**CITY OF BOULDER
PLANNING BOARD
MEETING DATE: October 22, 2020**

AGENDA TITLE: CONCEPT PLAN REVIEW for redevelopment of the property located at 1820 15th Street, Grace Commons Church (formerly known as First Presbyterian Church) for an addition to the existing church campus along with the redevelopment of the site referred as the church “annex” located at 1603 Walnut Street. Proposed on the main church campus is demolition of an existing addition and construction of new building area for a total of approximately 104,873 square feet on the campus. Planned uses include assembly and recreation space, along with meeting rooms, with building height up to 49 feet. Proposed at the annex property at 1603 Walnut Street is a new four-story, 55-foot tall mixed use building with ground floor non-residential uses including church assembly space, a small café, and ground floor parking, along with 30 permanently affordable residential units on the second and third floors, and an event space and deck on the fourth floor. Reviewed under case LUR2020-00033.

Project Name: Grace Commons Church Renovation/Addition & Grace Commons Annex
Location: 1820 15th Street and 1603 Walnut Street
Size of Proper

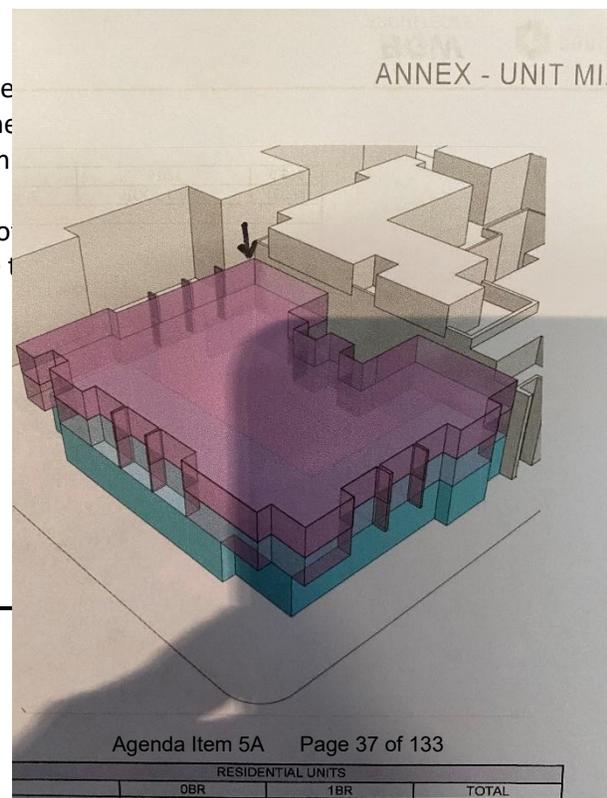
Regarding the plans, the Annex plan is showing that I will have a dire
However all units have balconies - all but the last one don't have one
I don't know if it was a mistake or not so I ask a clarification. I attach

I m also concern about the noise of the machine (HVAC) at the top o
spent time in my balcony. I will face directly machines/ noise all the t
rooftop.

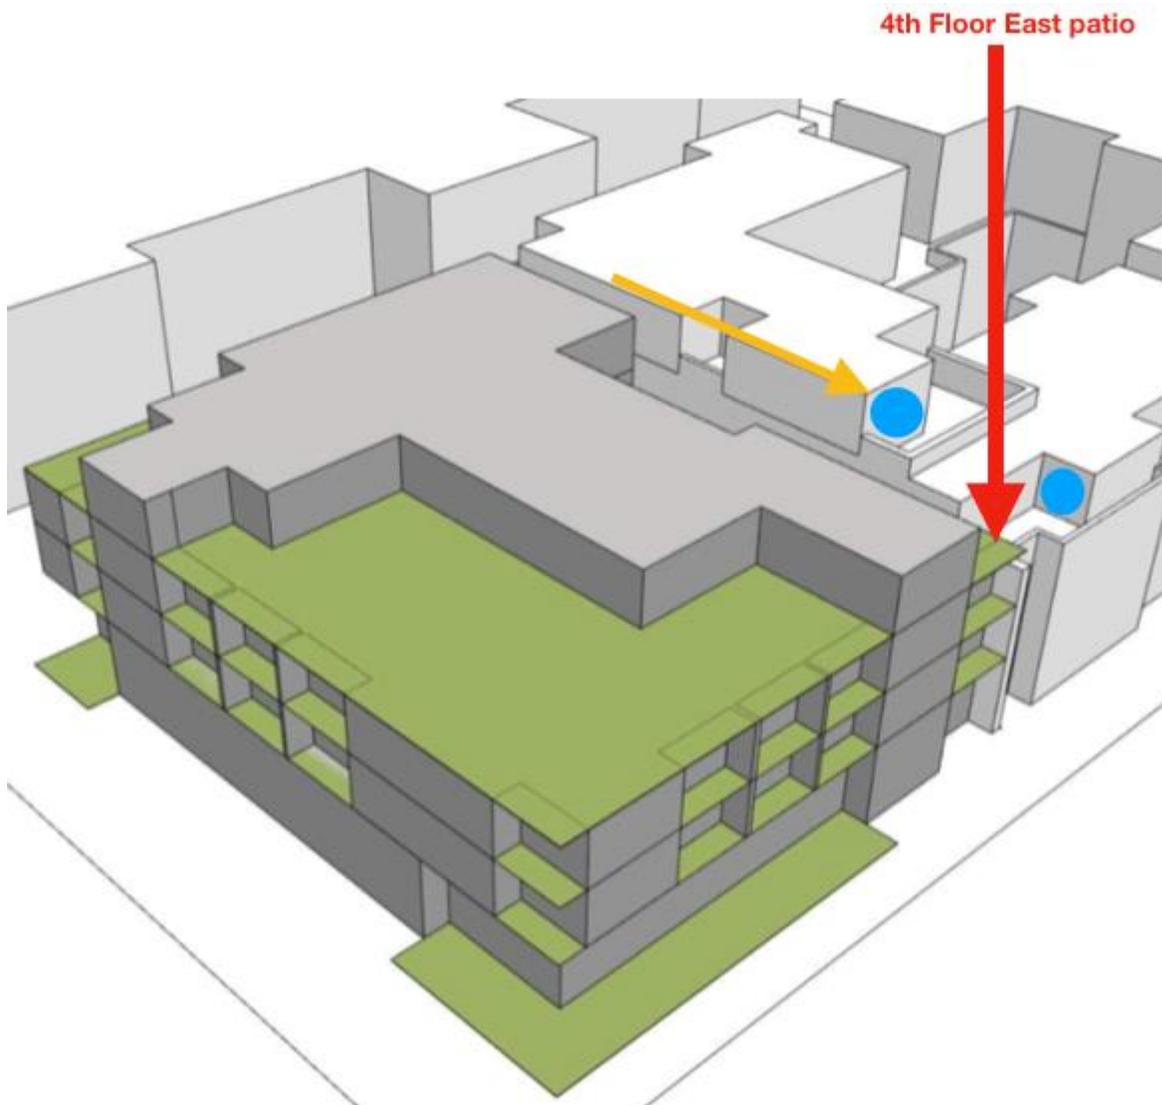
1. If there is a 4th floor balcony on the east side, people will be looking directly into my bedroom (shown with a blue circle) and my neighbors bedroom/patio on the third floor.

2. The Annex plan is asking for a 4th floor modification but has a brick 4 story structure coming all the way to the sidewalk, and not sitting back as is consistent with most architectural modifications in Boulder. I don't know the terminology for this but that 4 story facade is imposing and unfriendly. Is this even allowed, without "stepping back" in the upper floors?

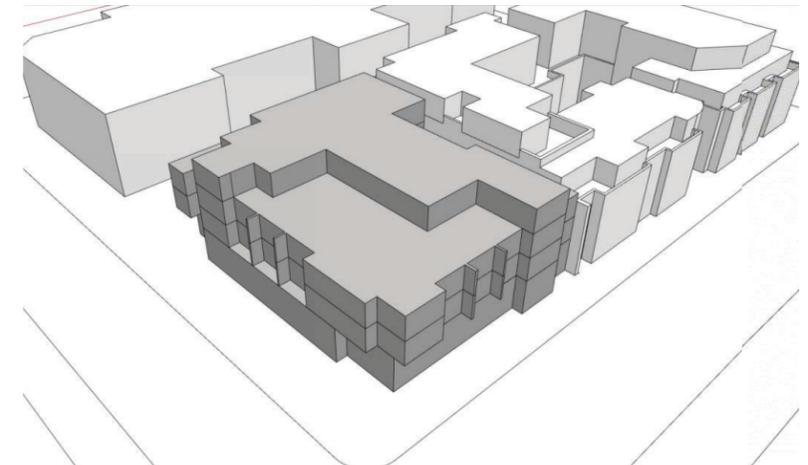
plate covering or is it open all the way to the ground from the upper stories?

PROPOSED MASSING

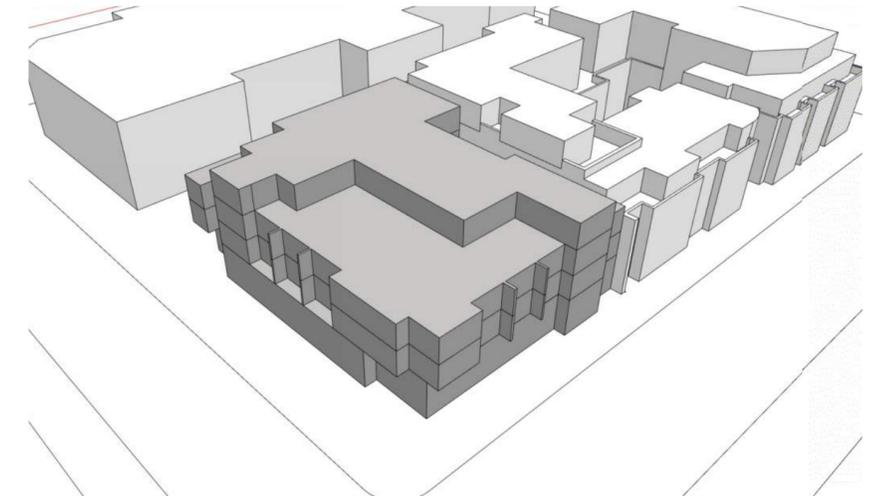
plate covering or is it open all the way to the ground from the upper stories?

plate covering or is it open all the way to the ground from the upper stories?
